Review of C&H Hog Farms Application for Arkansas Pollution Control and Ecology Commission Regulation 5, Liquid Animal Waste Management System Permit

M. D. Smolen, Ph.D. Water Quality Specialist
Lithochimeia, LLC.

April 4, 2017

FIGURE 2 ALL-SEASON PMP (IN.) FOR 24-HR 10 SQUARE MILE AREA EAST OF THE 105 DEGREE MERIDIAN

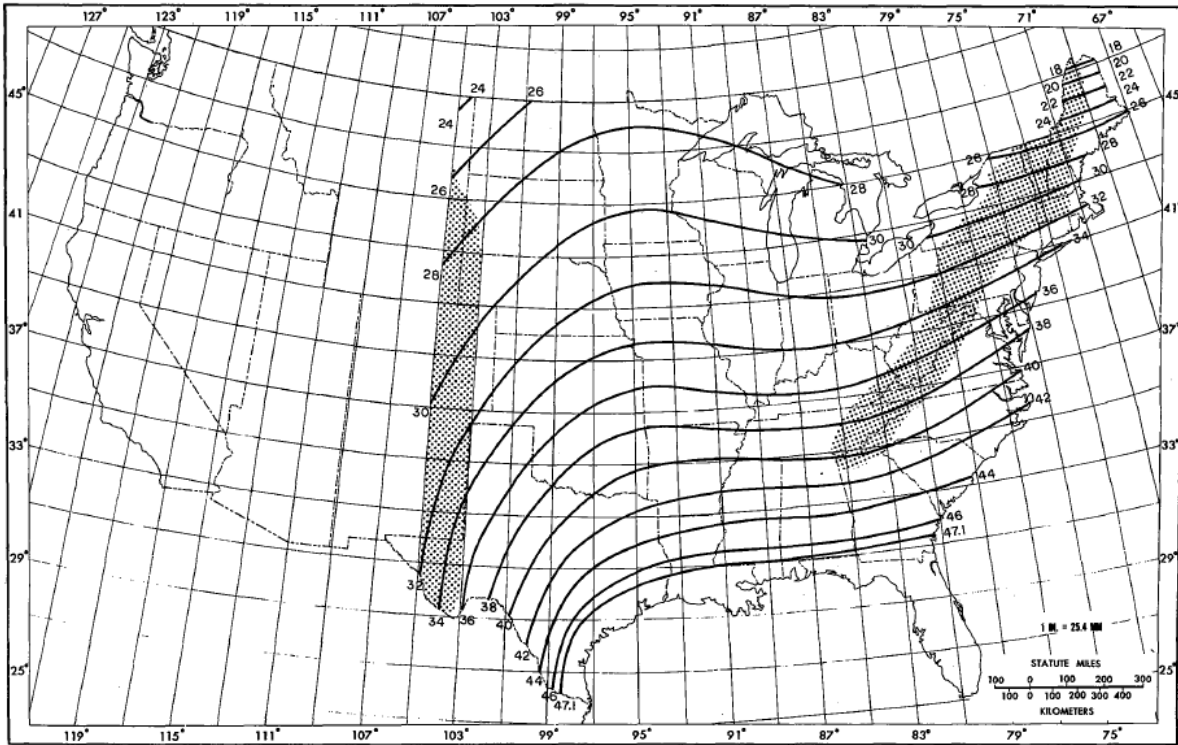
The water level management specified in the Regulation 5 permit is based on **no discharge**, but the design guidance from the NRCS Waste Management Field Handbook is based on allowing discharge from a storm greater than the 25-yr 24-hr storm. If no discharge is allowed, a different design criterion, such as “Probable Maximum Precipitation” (PMP) (see Figure 2) should be used for design and management. Estimates of PMP were developed by the National Oceanic and Atmospheric Administration (NOAA) According to the NOAA analysis, the PMP for this area in Arkansas would be about 40 to 42 inches, about twice the volume currently reserved for the design storm and freeboard.

- The waste holding ponds should be designed and operated to a higher standard than the NRCS Agricultural Waste Management Field Handbook (AWMFH) because Regulation 5 requires “no discharge.” The 25-yr 24-hr storm would be acceptable under a discharge permit like the Regulation 6 NPDES permit, but Regulation 5 is a “No Discharge Permit” and should require a higher standard such as NOAA’s Probable Maximum Precipitation.

FIGURE 4 EXAMPLE OF A FIELD 21A, WHICH IS CONTORTED AND INAPPROPRIATE FOR WASTE APPLICATION

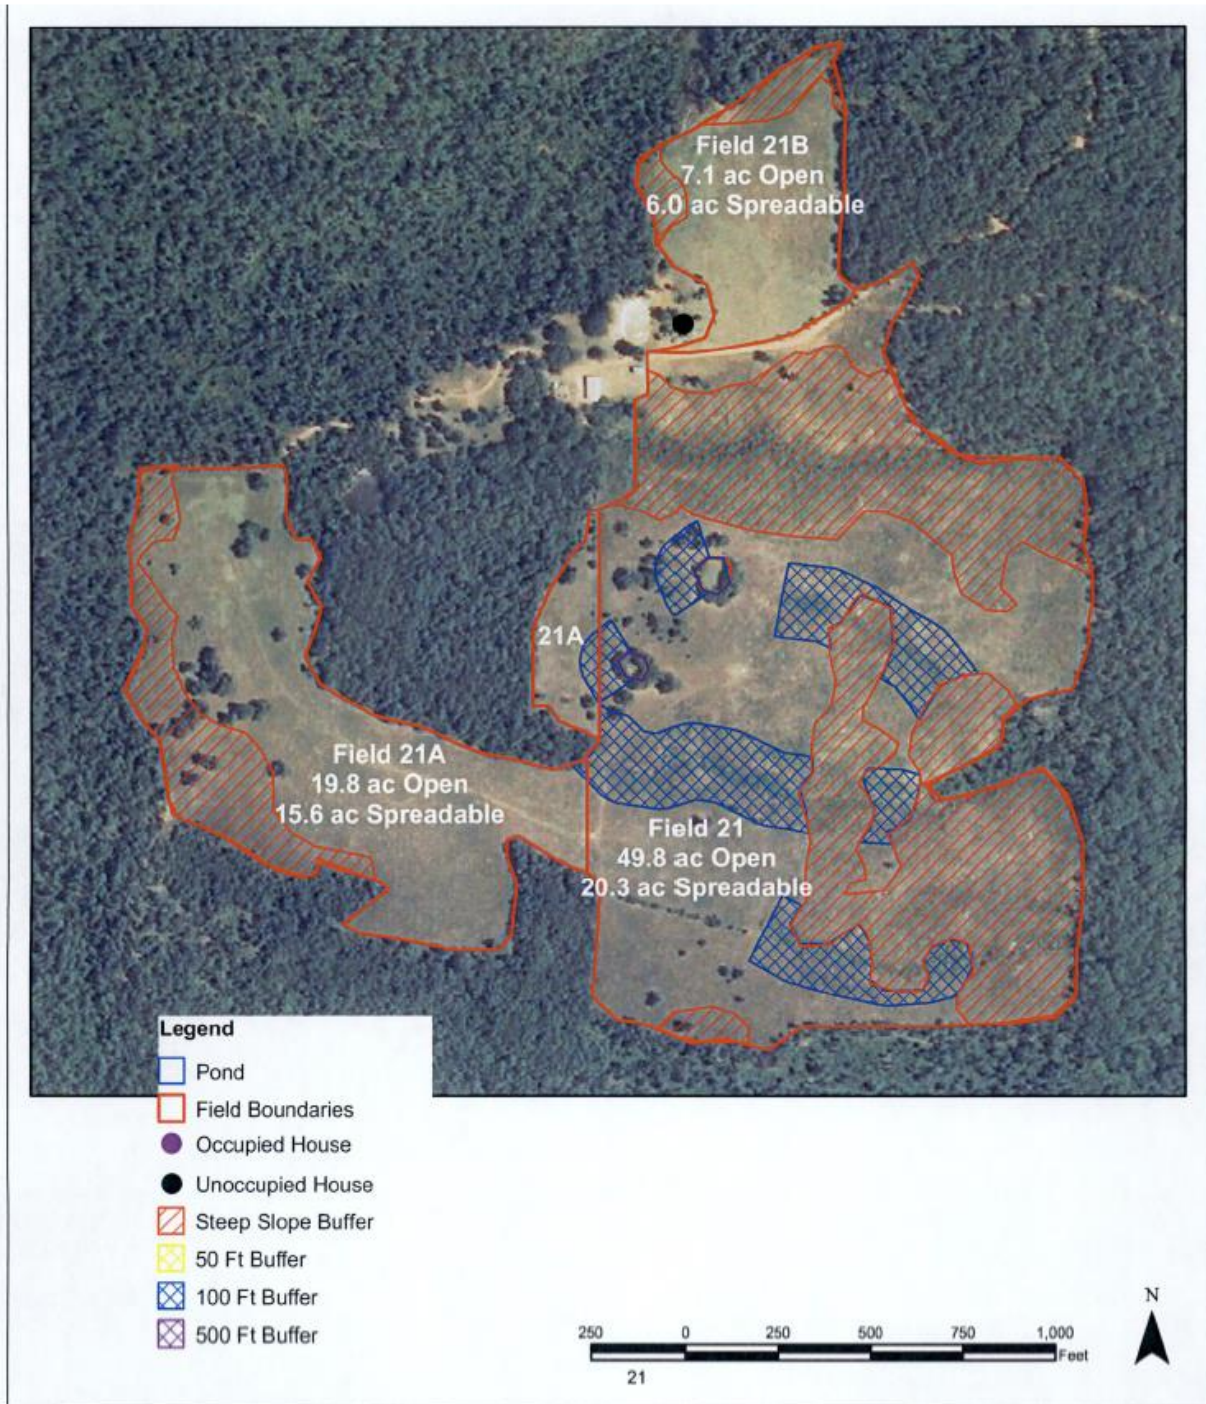
The last column of Table 1 also shows my assessment of each field’s suitability for waste application based on shape and steepness. Most fields in the NMP have reasonably good shape, with large open areas where a spray rig could maneuver easily to follow boundaries of buffer zones. Some, however, have few restricted areas, or at least areas that are easy to identify. Several fields, however, are so contorted, with odd shaped buffer areas and steep slopes, it would be difficult or even impossible to follow. Examples of fields with severe limitations include fields 2, 4, 6A, 11, 13B, 20, 21A, and 21B. Figure

4 shows the example of Field 21A, where an operator would have difficulty. These six fields include 71.5 acres that should be removed from the permitted application area.
